REQUEST

Current Zoning: R-3 (single family residential)
Proposed Zoning: UR-2(CD) (urban residential, conditional)

SUMMARY OF PETITION

**STAFF
RECOMMENDATION**

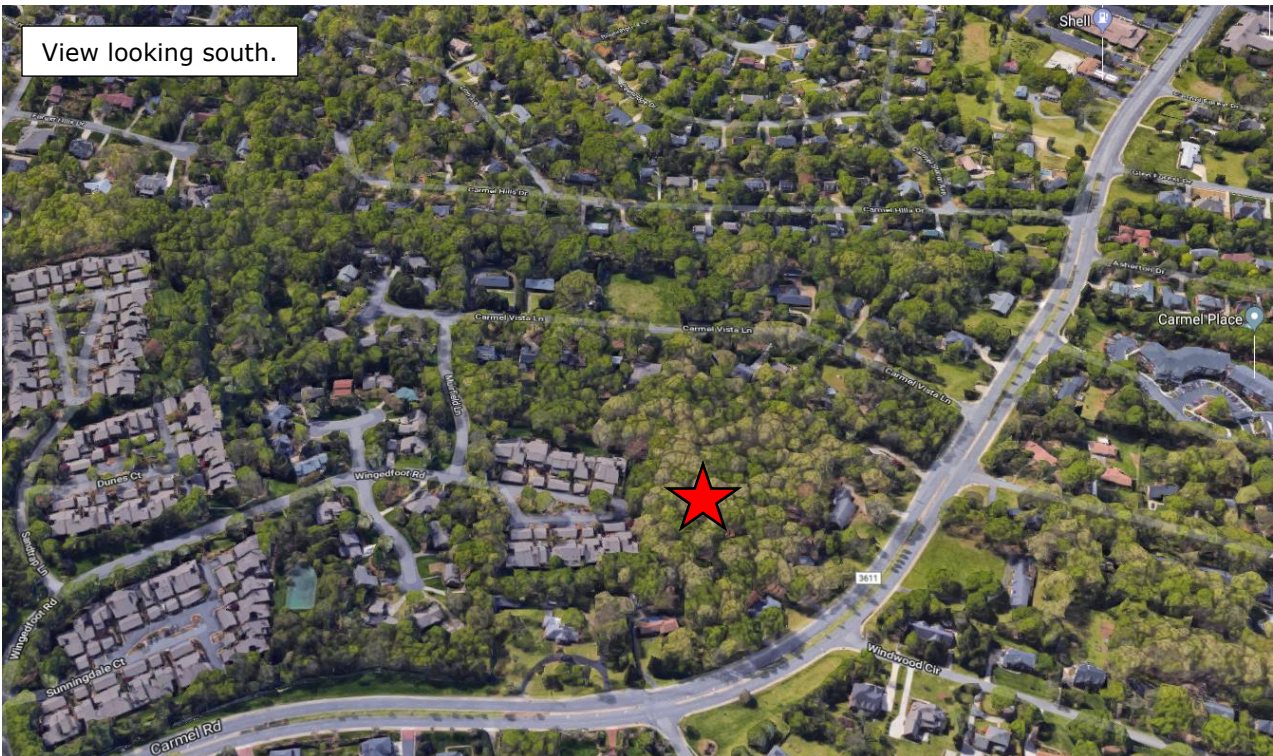
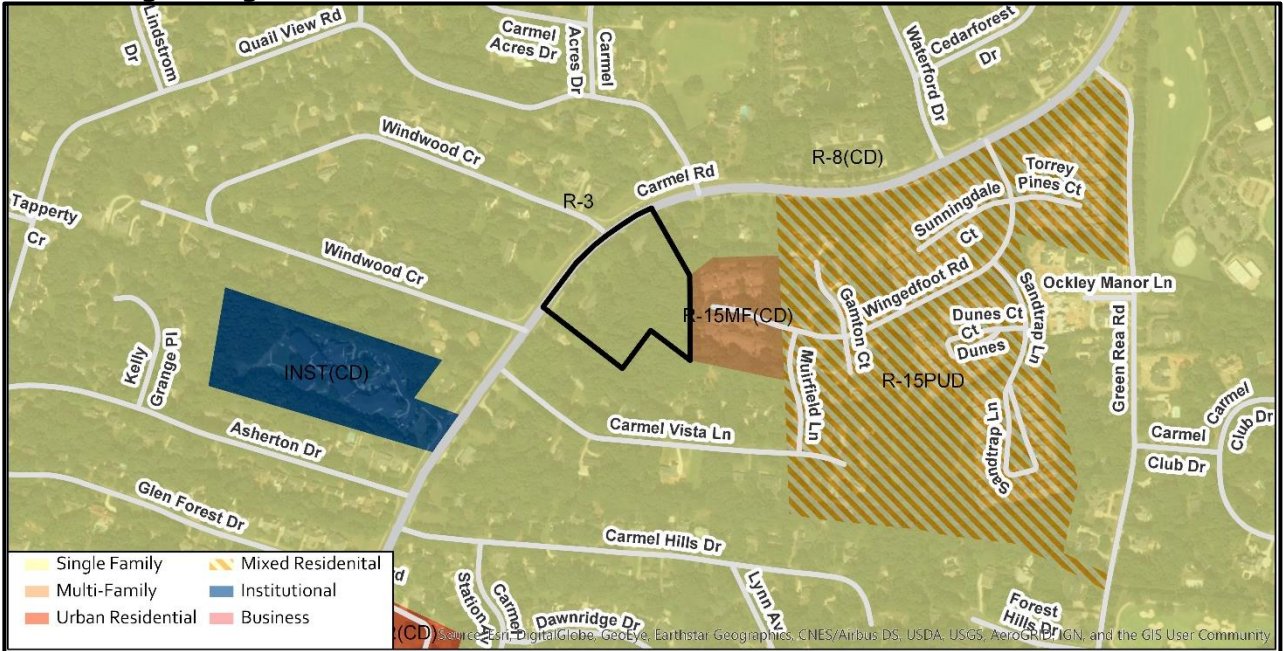
- Site plan indicates a 75 foot building setback for the single family detached homes and approximately 55 foot setback for townhomes from Carmel Road.

- Provides a 31-foot class C buffer between area developed with townhomes and adjacent single family use and zoning.
- Site access from Carmel Road and specifies no connection will be made to Wingedfoot Drive. Provides a network of internal, private drives and sidewalks to provide access to the dwelling units. The single family detached dwelling units will be rear loaded from a shared access driveway.

- Notes an allowable possible future connection to the internal private driveway from the adjacent single family parcel north of the site in the event those parcels redevelop.

- Installs a 16-foot planting strip and 6-foot sidewalk along Carmel Road.
- Provides a landscaped plan with commitments for enhanced landscaping and screening fence along Carmel Road. Commits to installing an irrigation system for the enhanced landscaped area. *In discussions with the surrounding neighborhoods the petitioner has increased the size deciduous trees, except those located under overhead utilities. The petitioner also increased the number evergreen trees around the hammerhead turnaround.*

- Commits to a minimum of 5 visitor parking spaces and specifies that each unit will have a 2 car garage and a minimum 20-foot parking pad.
- Provides architectural standards related to treatment of side/end units facing Carmel Road, number of units in townhome buildings, allowed building materials, raised entrances, pitched roofs, usable porches and stoops and garage doors. Although not requested by Planning, the petitioner specifies the minimum size of each townhome unit, exclusive of garage will be 1,800 square feet and single family detached homes, exclusive of garage will be 3,000 square feet.

- Limits the height of pedestrian scale, freestanding lighting to 15 feet.
- Specifies entry signage, if provided, will be of similar building materials as the buildings and lettering will not be internally illuminated.

- Provides perspective view concept from Carmel Road and cross-section from Carmel Road into site.
